Mask Set Errata for Mask 0L16X

This mask set errata applies to the mask 0L16X for these products:

- MC9S08AW60
- MC9S08AW48
- MC9S08AW32
- MC9S08AW16

Figure 1. HCS08 SIM Reset Lockup

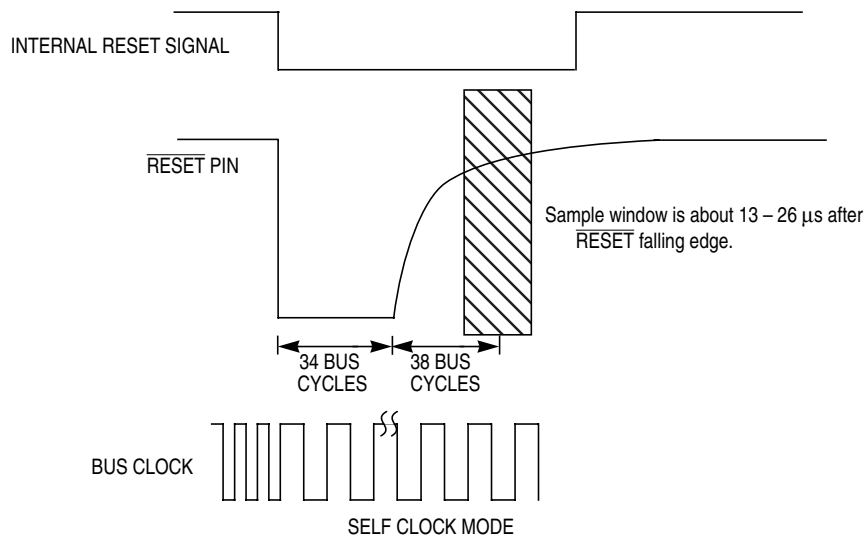
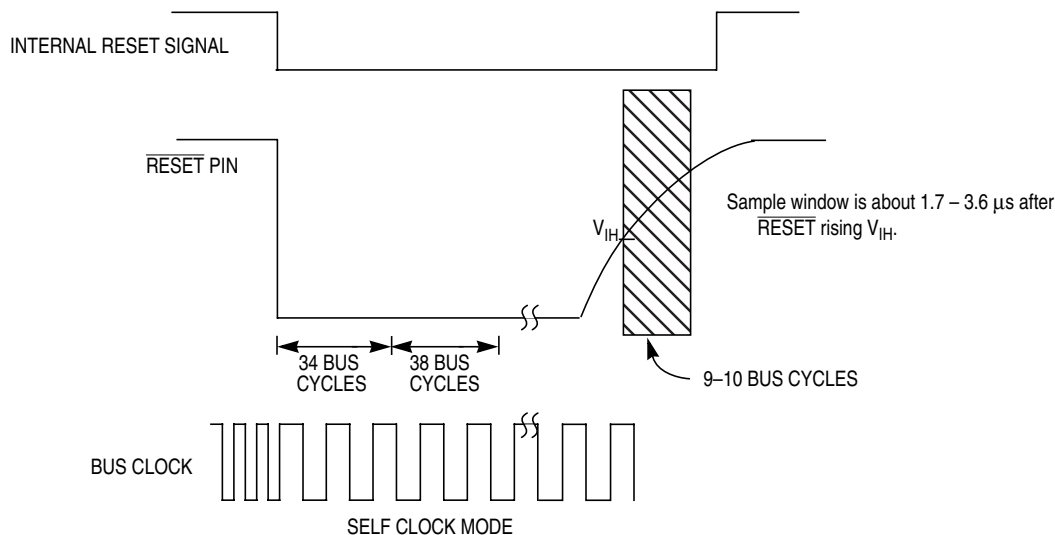
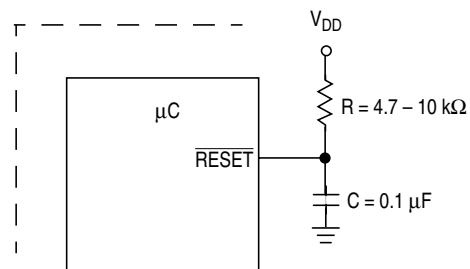
HCS08 with ICG — Falling Edge on $\overline{\text{RESET}}$ During Termination of Reset Events

If a falling edge is detected on the external reset pin at either of two sample points, the MCU will cease operation and will recover only after a power-on reset.

Case 1 — After detecting a reset signal, either internal or external, the internal reset circuit latches the cause of the reset, forces a low level on the external $\overline{\text{RESET}}$ pin for about 34 bus cycles, releases the pin, and samples the pin level about 38 bus cycles later. The ICG will revert to self-clock mode (SCM) at the beginning of the reset cycle. Therefore, the first sample window is about 13 μs to 26 μs after the initial reset signal, due to the frequency range and characteristics of the internal oscillator.

Case 2 — After remaining in reset for an extended period of time due to an externally applied low level on $\overline{\text{RESET}}$, the internal reset circuit will sample the pin level about 9 to 10 bus cycles after the pin raises above its V_{IH} level. The ICG will revert to self-clock mode (SCM) during reset. Therefore, the second sample window is about 1.7 μs to 3.6 μs after the reset signal rises above V_{IH} , due to the frequency range and characteristics of the internal oscillator.

To avoid multiple edges on the $\overline{\text{RESET}}$ pin due to switch contact ringing or EMC noise, eliminate any voltage bounce through RC filtering. A 0.1 μF capacitor to ground and an external 4.7 k Ω to 10 k Ω resistor to V_{DD} works well to ensure noise suppression.

In addition to RC filtering, avoid spurious edges on the $\overline{\text{RESET}}$ pin caused by external active circuitry such as low voltage detectors and watchdog components. Do this by ensuring that external circuitry cannot drive $\overline{\text{RESET}}$ low within 10 bus cycles of the release of $\overline{\text{RESET}}$.
